RISK AREAS FOR DEVELOPMENT DUE TO UNDERMINING CONSTRAINTS THREE SISTERS RESORTS

TO: The Mayor and Town Council of Canmore
RE: Three Sister's Resorts Proposed Development

Factor of Safety as it Relates to Hazards associated with Canmore's Friable Coal

MAP "A"

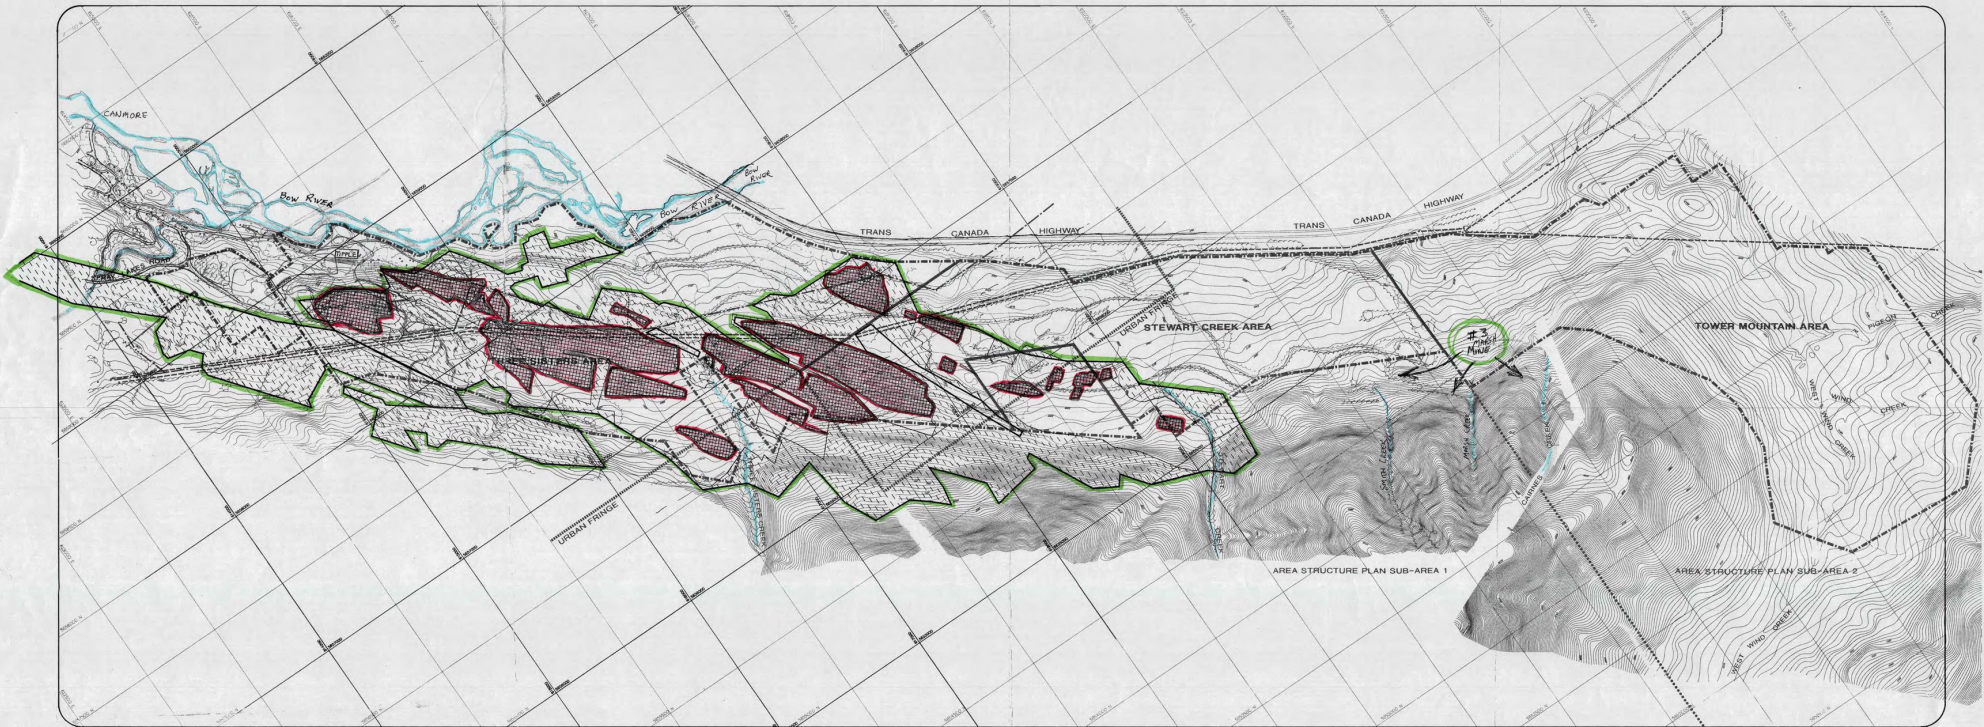
While working on the guidelines, a unanimous decision was made by the Committee and was site specific. Only a golf course was considered to be viable (with a caveat). That decision by the Undermining Committee was based on the following geotechnical hazards and the UWM constraint Map A associated with this specific area:

I see nothing in the Three Sisters 2021 Area Structure Plan that would change the original decision of the Undermining Review Committee and UWM's constraint Map A; there is to be No Development except for the golf course in this area with the caveat - no building over high constraint areas. (see UWM Map A)

Derek Steele was looking at constraint Map A when TSR consultant Gerry Stephenson suggested we head to the site of the proposed golf course. Derek Steele proceeded to tell Gerry that we would not be visiting the site because there were areas on site too dangerous to walk on and should not be included as part of the golf course. He also said that some of the sites picked by TSR for club houses would have to be moved because of the hazards and subsidence dangers associated with the underlying vertical coal seam workings and pointed to the Non Development Risk Areas highlighted on UWM constraint map submitted by TSR to the Town of Canmore. (see Map A)

This decision was also based on the included Map A; Risk Areas for Development Due to Undermining Constraints on which areas of Non Development were highlighted. Map A was the result of the analyzing of the geotechnical hazards associated with past mining activity by UWM geotechnical experts and submitted to the Town of Canmore on behalf of Three Sisters Resorts. (1990's)

MAP "C"

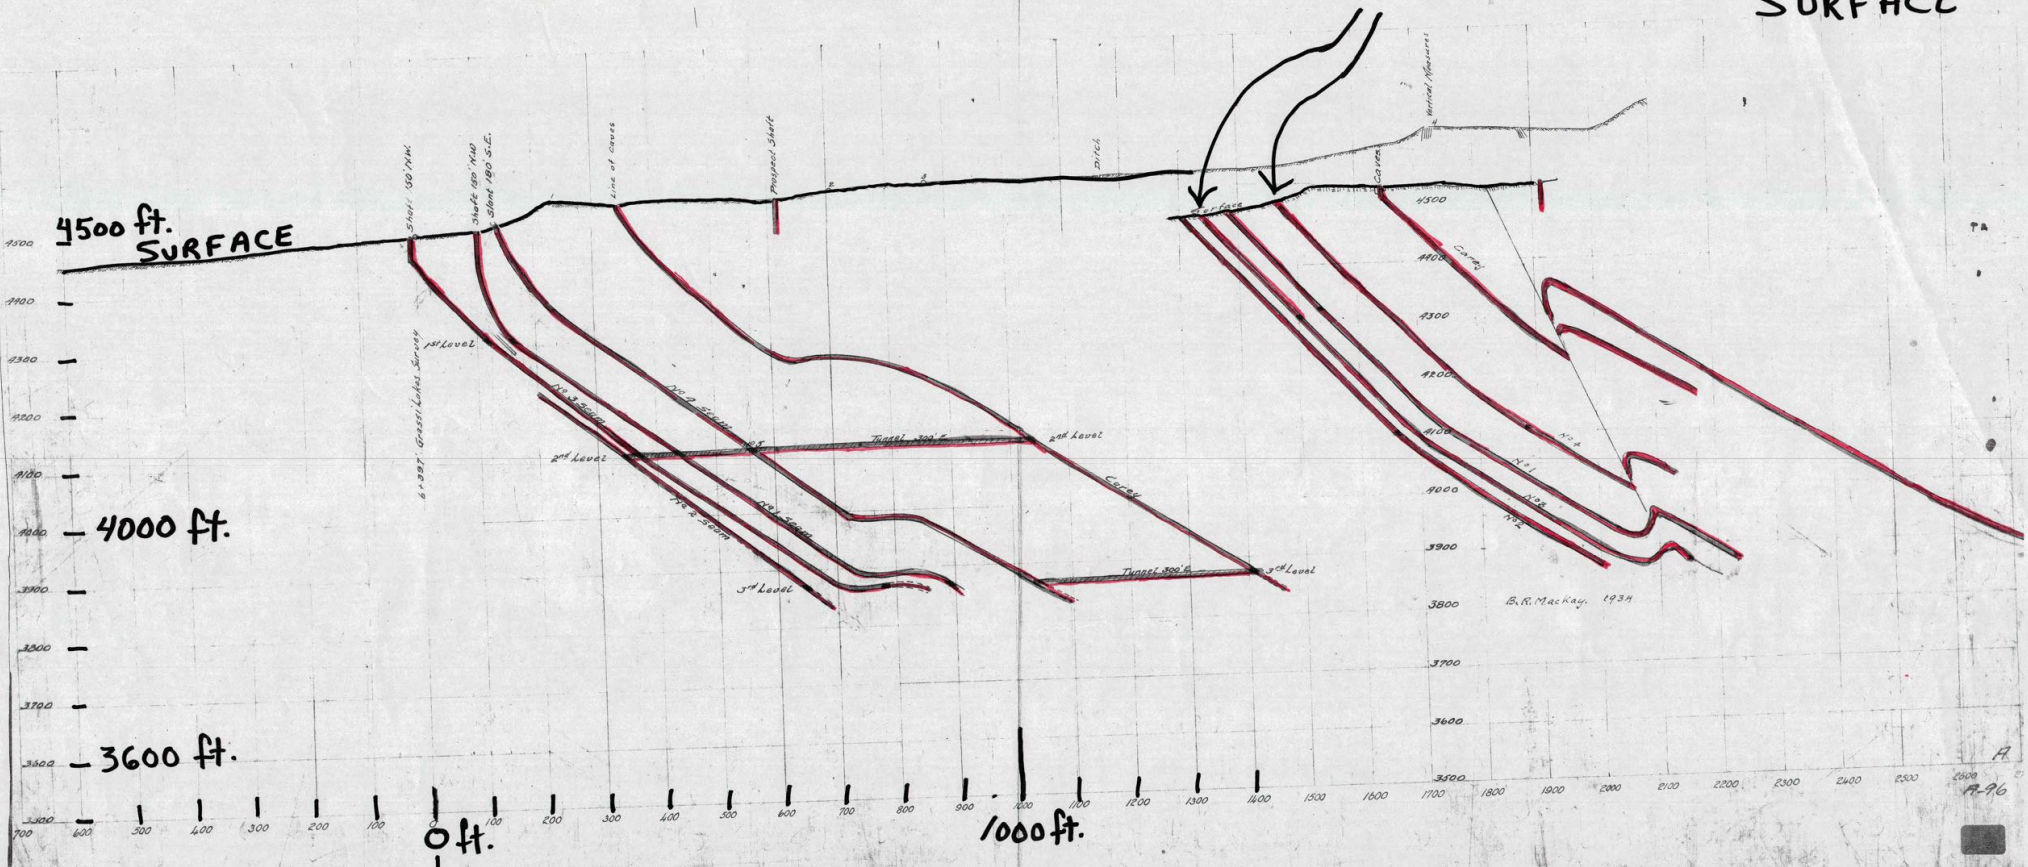
...Map C - is Vertical Section A; shows complexity of Carey and seams 1; 2; 3; 4. Its location is just west of where Three Sisters Parkway collapsed and just east of Spray Lakes Road where migrating Voids are to be mitigated/filled with concrete in 2021. The voids are the result of mining Seams 1; 2; 3 and 4 over 100 yrs ago.

Pit subsidence and trough subsidence will and does occur over time, from decades to centuries. Migrating voids take time to reach the surface. Case in point is the Spray Lakes Road where it crosses mined coal seams associated with the No. 1 Mine. (seam No. 's 1; 2; 3 ;4) This area was mined over 100yrs ago and it is only now that the migrating voids associated with past mining activities are approaching the surface. This area of highway is now undergoing remedial work. These voids will be filled with concrete before the end of the year (2021). Multiple seams only complicate remedial actions as they can increase the size of the migrating voids. (see Map C; Vertical Section A; and pit and sag subsidence illustrations).

FIGURE 8 SCHEMATIC DIAGRAM SHOWING A PROBABLE RELATIONSHIP BETWEEN WORKINGS ON A DIPPING COAL SEAM AND ASSOCIATED SUBSIDENCE RISK ZONES

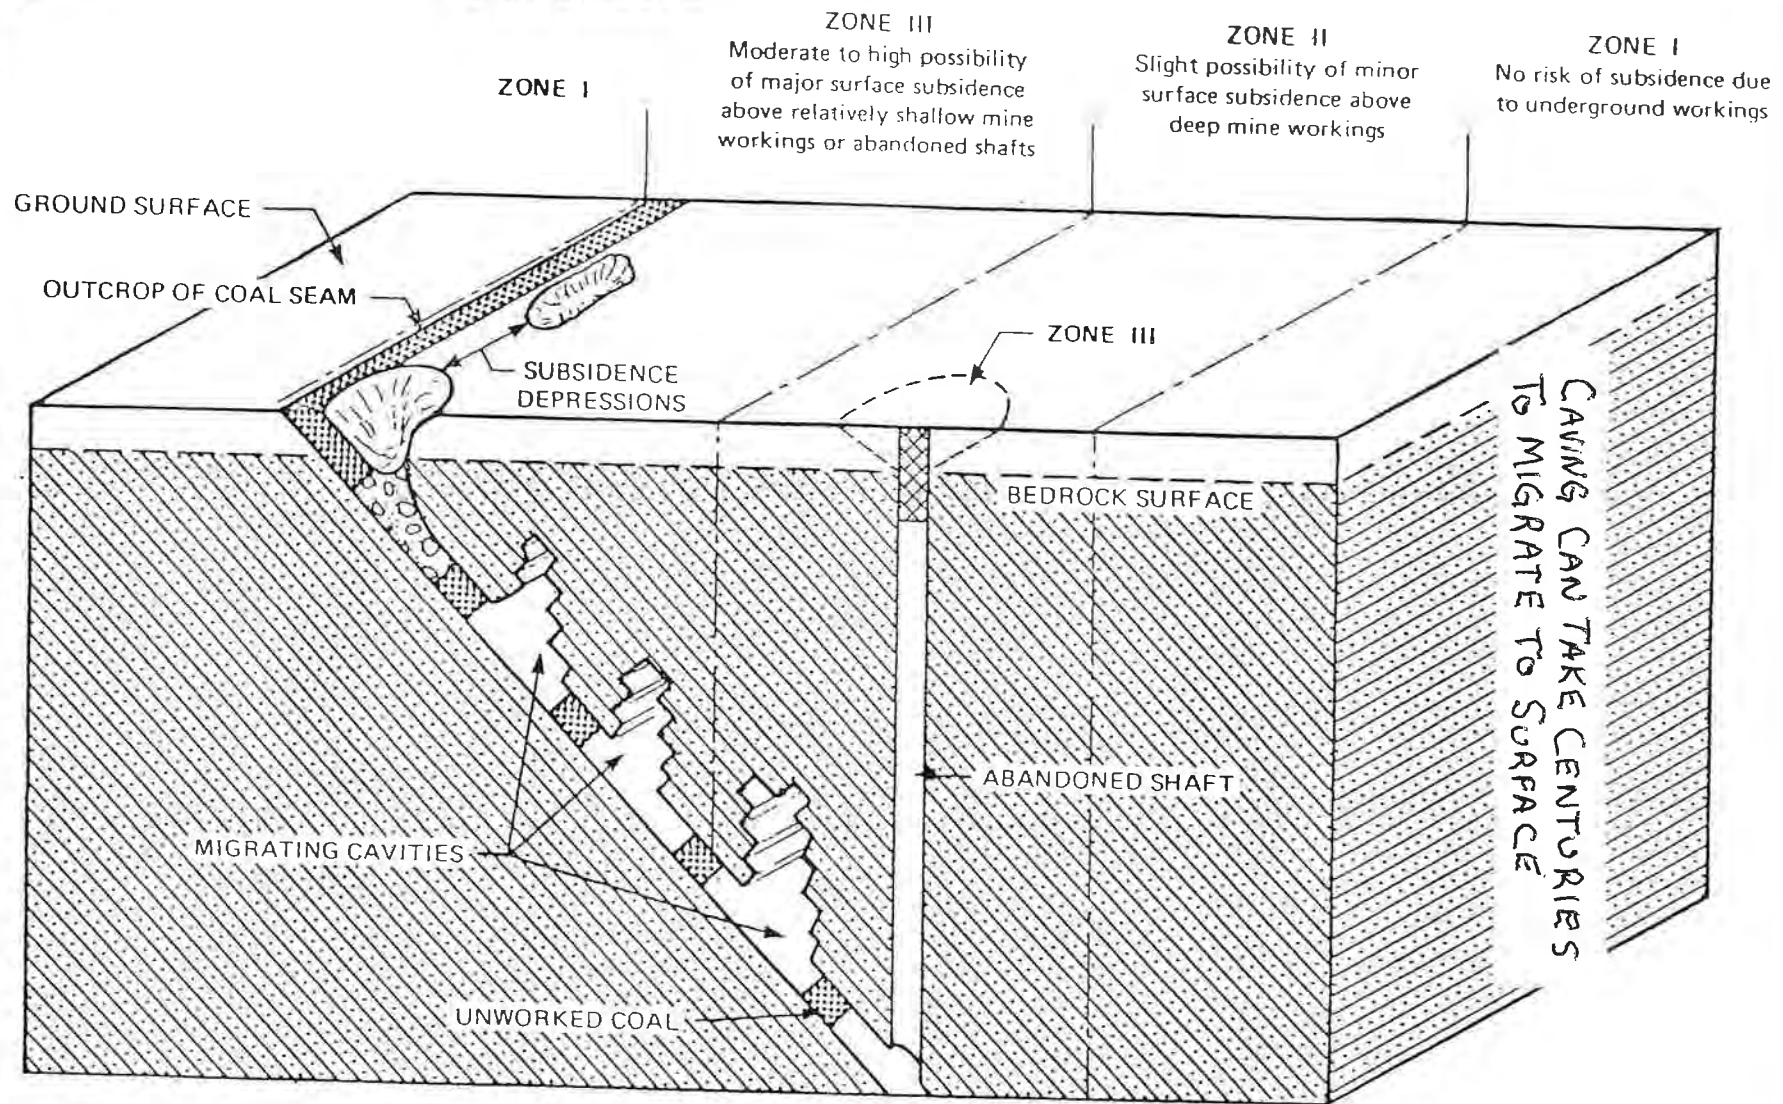
FLOODING ACCELERATES THE MOVEMENT OF DEBRIS FROM CAVING DOWNSLOPE

RISK ASSESSMENT COMPLICATED BECAUSE CANMORE COAL IS FRIABLE COAL

SAG OR DOWN WARPING IS MORE COMPLICATED OVER UNDERMINING OF MULTIPLE DIPPING SEAMS WHEN COAL IS CLASSIFIED AS FRIABLE

Figure 10. Block diagram of a typical sag subsidence event:

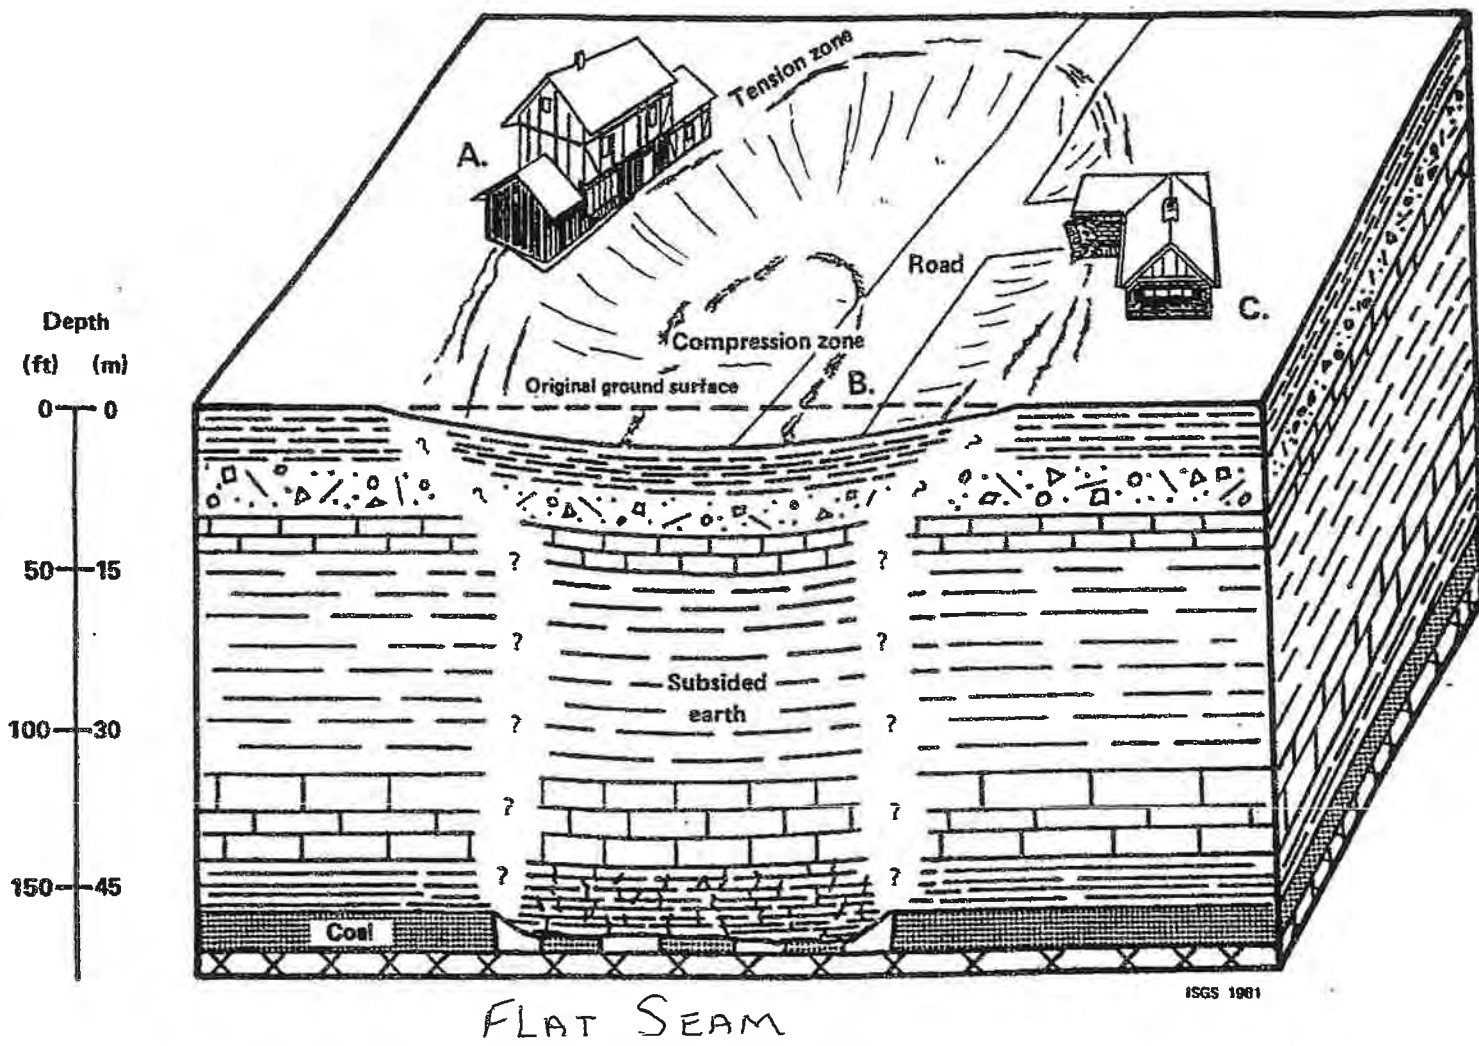
RISK ASSESSMENT OF CANMORE COAL (FRIABLE) SEAMS (DIPPING/VERTICAL) IS COMPLICATED (MANY VARIABLES TO BE CALCULATED)

SAG HAS YET TO OCCUR IN AREAS WHERE CAVING IS NOT YET ACTIVE. BUT IS DAMAGING TO OVERLYING DEVELOPMENT/UTILITIES WHEN IT DOES OCCUR.

Figure 8. Cross section and photograph of a typical pit subsidence event (after Wildanger et al., 1980).

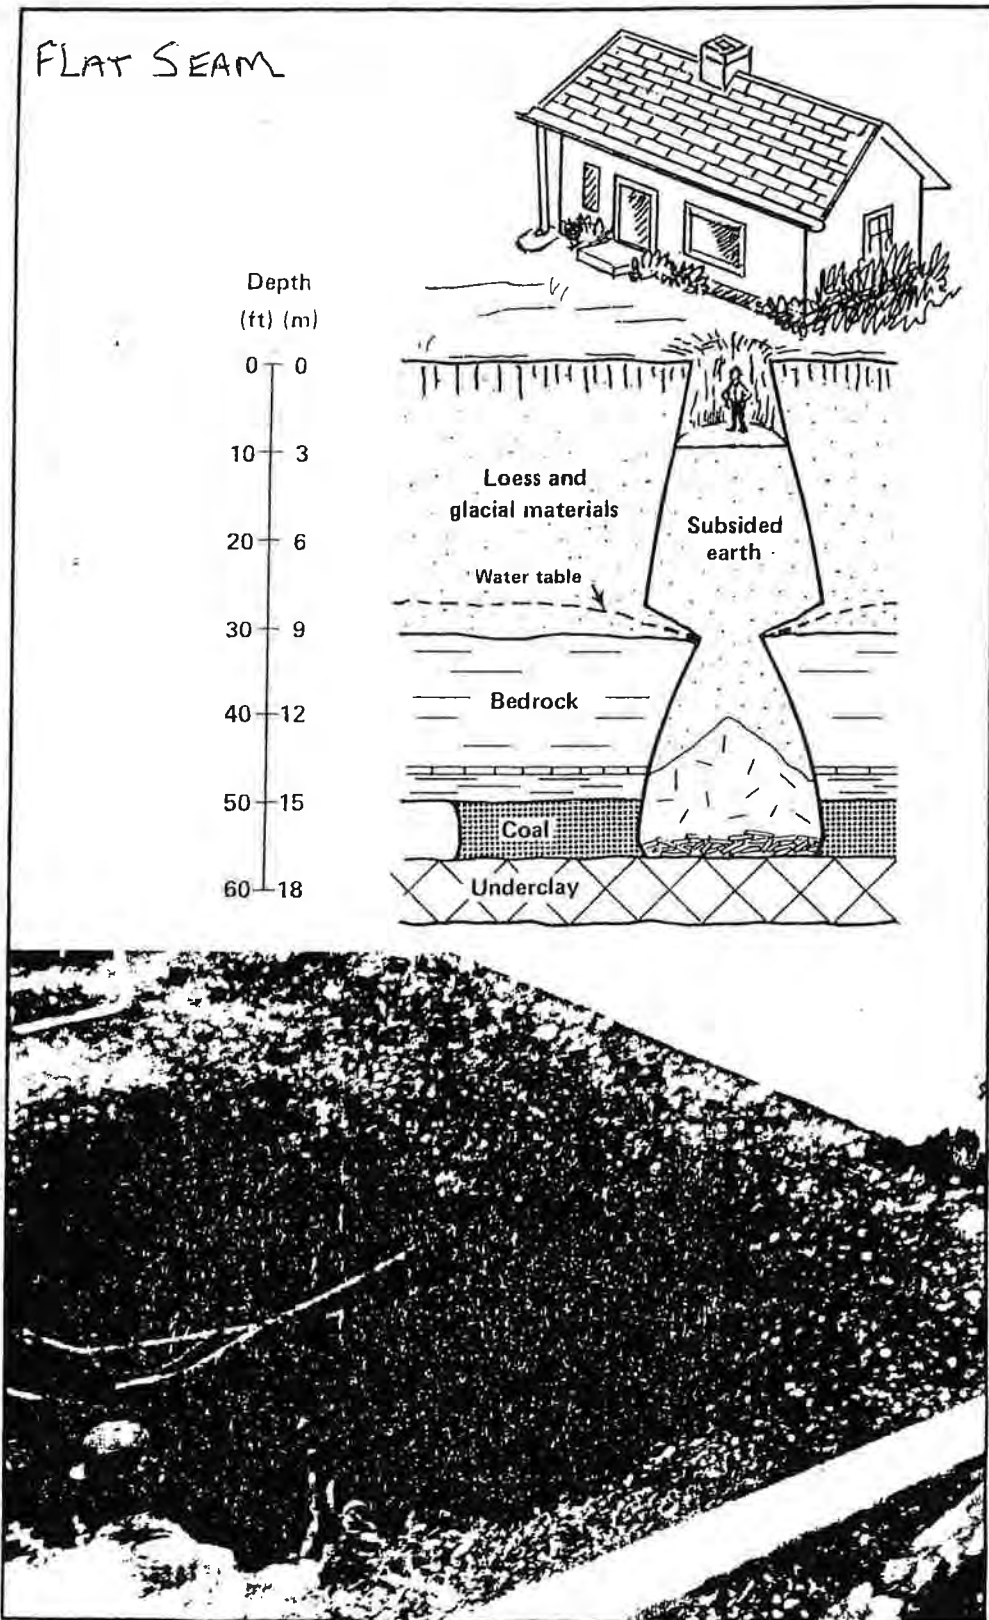
PIT SUBSIDENCE IS VERY COMPLICATED IN CARMORE
MULTIPLE SEAMS / DIPPING SEAMS / FRIABLE COAL
